Reply to Comment from Referee 1 on EGUSPHERE-2024-902

Review of egusphere-2024-902: Technical Note on high frequency, multi-elemental stream water monitoring: experiences, feedbacks and suggestions from seven years of running three French field laboratories (Riverlabs).

Reply to Comment from Referee 2 on EGUSPHERE-2024-902

Figure 9: Data management workflow of the Critex Riverlabs and associated challenges. QC/QA: quality control/quality assurance; O₂: dissolved oxygen concentration, T°: water temperature, EC: electrical conductivity in water; [DOC]: dissolved organic carbon concentration

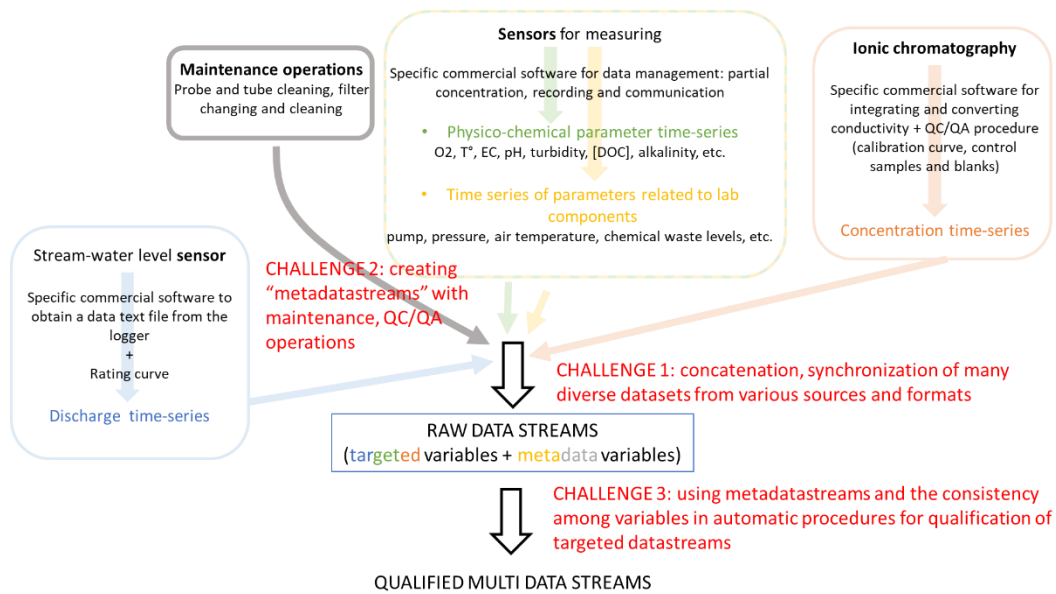
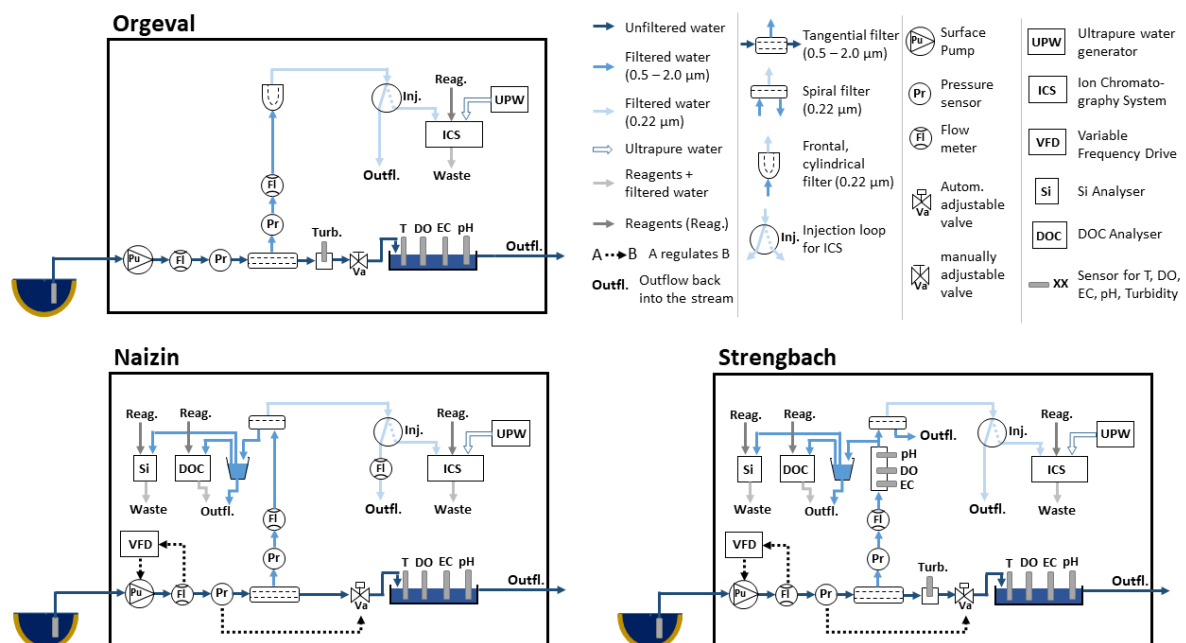
The technical note lacks a discussion on the challenges of data management and the software development necessary for the automation and analysis of large data volumes. Including a detailed section on this topic would greatly enhance the usefulness of the work for future deployments.

The methods section contains overly detailed operational descriptions. Consider moving some minor technical details to appendices to enhance the readability of the main text, and provide updated information on current methodologies, particularly regarding data management and software development.

Challenge 1 (Fig. 9) is therefore related to compilation of the various data sets, especially if sensors and technologies need to be synchronized (e.g., time lags, injection versus continuous flow analysis). In other cases, specific routines in the functioning of the Riverlab influenced certain measurements during specific periods. Interpreting these additional variations correctly required detailed technical knowledge. For example, programmed flushing of the entire pumping cycle artificially increased and decreased the temperature in the overflow tank slightly during the flushing. This rapid temperature variation in turn influenced the temperature-corrected electrical conductivity due to a lag in the temperature adaptation of the conductivity sensor. Another challenge (Challenge 3, Fig. 9) is thus related to translating this technical knowledge into algorithms that will use non-targeted monitored variables (e.g. room temperature, pressures, pump speed and velocity) to curate and qualify the monitored variables targeted (e.g. water temperature, pH, conductivity and concentrations).

- We identified several minor details to remove and transfer in appendix (in particular: paragraphs related to the variable frequency drive in section 3.1.1, to the freezing winter temperatures in section 3.1.2., and to the ventilation system in section 4.1.)
- We suggest adding several explicit references to the prototype designed for the station located in the US (in abstract, introduction, section 2.2. and conclusion, see please our reply to major comment 3 from J. Druhan)
- We suggest additional information in section 5.3 to develop the aspects related to data management and software:

“Producing long time series that are easily accessible and usable later often requires combining manual and automatic quality-control procedures. Data management thus includes several challenges, as highlighted for various high-frequency water-quality monitoring facilities (Cassidy and Jordan, 2022). We identified three main challenges associated with data management (Fig. 9). In our

experience, detailed technical knowledge of effects of the components and their interactions on measurements is also required. The ion concentration time series from the ICS was validated regularly and manually by technical staff members, who were maintaining the ICS and were thus aware of any relevant malfunctions or inaccuracies. This procedure allowed us to remove non-validated measurements from the time series. Challenge 1 (Fig. 9) is therefore related to compilation of the various data sets, especially if sensors and technologies need to be synchronized (e.g., time lags, injection versus continuous flow analysis). In other cases, specific routines in the functioning of the Riverlab influenced certain measurements during specific periods. Interpreting these additional variations correctly required detailed technical knowledge. For example, programmed flushing of the entire pumping cycle artificially increased and decreased the temperature in the overflow tank slightly during the flushing. This rapid temperature variation in turn influenced the temperature-corrected electrical conductivity due to a lag in the temperature adaptation of the conductivity sensor. Another challenge (Challenge 3, Fig. 9) is thus related to translating this technical knowledge into algorithms that will use non-targeted monitored variables (e.g. room temperature, pressures, pump speed and velocity) to curate and qualify the monitored variables targeted (e.g. water temperature, pH, conductivity and concentrations).
